LISTING OF PROJECT REVISIONS						
DATE	SHEET NUMBER	DESCRIPTION OF REVISIONS	DATE	SHEET NUMBER	DESCRIPTION OF REVISIONS	
11-20-07	1A	REVISION SHEET ADDED.				
11-20-07	65-76	WALL ELEVATIONS REVISED. REASON: GRADING CHANGES TO ACCOMMODATE 3' BERM IN FRONT OF ABUTMENTS.				
11-20-07	80 & 81	SUBDRAIN ELEVATIONS REVISED. REASON: REVISED WALL ELEVATIONS.				
01-18-08	4 & 52	ADDED STEEL PEDESTRIAN HAND RAILING TO THE EAST SEPERATION BARRIER REASON: PER IadOT'S REQUEST				
01-23-08	4, 5,9 & 11	REVISED QUANTITY ITEMS NO.4 & 7 REVISED LOW STEP ELEVATIONS AT PIER NO.1 REVISED PIER STEP ELEVATIONS AND HEIGHTS REVISED PIER STEP REINFORCING AND QUANTITIES REASON: ACTUAL DISC BEARING HEIGHTS ARE SHALLOWER THAN ASSUMED.				
04-09-08	12, 13, 14, 15, 19 & 20	THESE SHEETS DELETED REASON: CONTRACTOR VE PROPOSAL TO REPLACE STONE VENEER ON OUTSIDE FACE AT ABUTMENTS WITH FORM LINER.				
04-09-08	12A, 13A, 14A, 15A, 19A & 20A	THESE SHEETS ADDED REVISED DETAILS, NOTES, DIMENSIONS & REINFORCING REASON: CONTRACTOR VE PROPOSAL TO REPLACE STONE VENEER ON OUTSIDE FACE AT ABUTMENTS WITH FORM LINER.

DESIGN FOR 0° SKEW
353'-6X82' CONT. WELDED GIRDER BRIDGE
W/8'-4 SIDEWALK & 10'-4 SHARED USE PATH
24TH STREET OVE

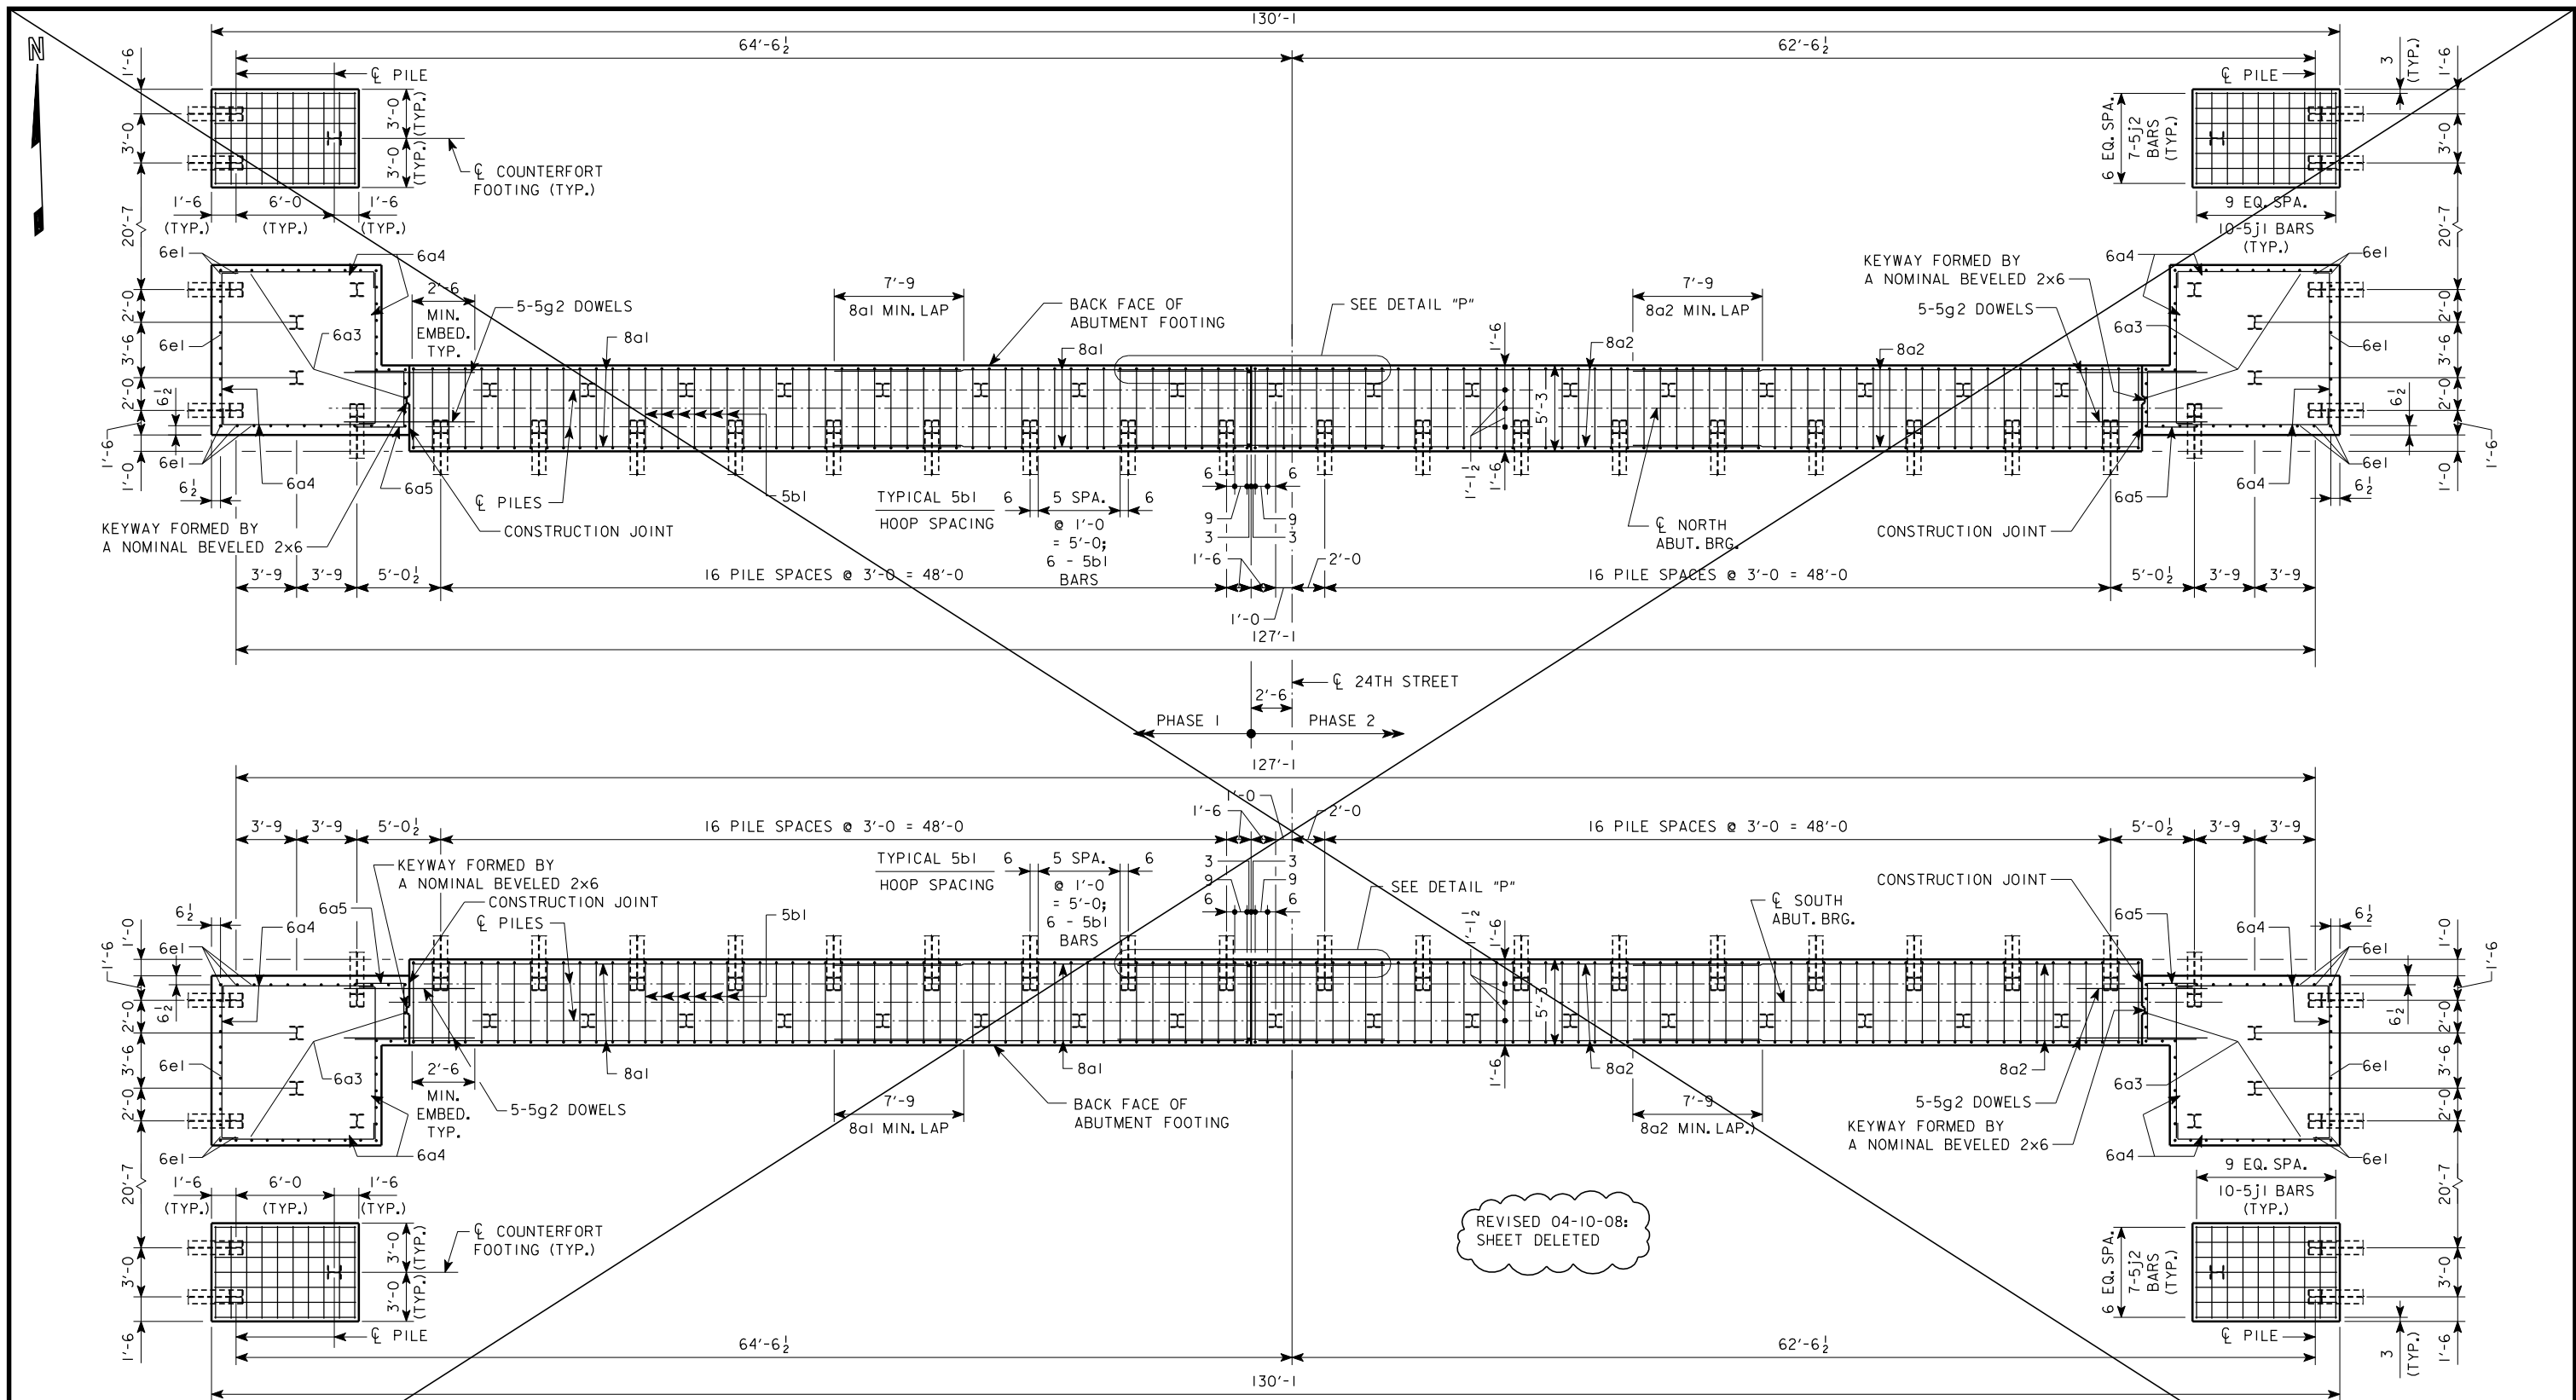
REVISED 04-10-08:
REVISED QUANTITY ITEM NO. 15.

REVISED 04-09-08:
REVISED QUANTITY ITEMS
NO. 4, 7, & 22.

REVISED 01-23-08,
REVISED QUANTITY ITEM NO. 4
REVISED QUANTITY ITEM NO. 7

REVISED 01-08-08,
REVISED QUANTITY ITEM NO. 13

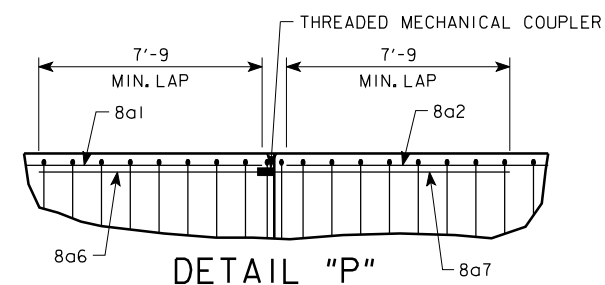
REVISED 04-10-08:
ADDED PILES AT
ABUTMENT CORNERS.
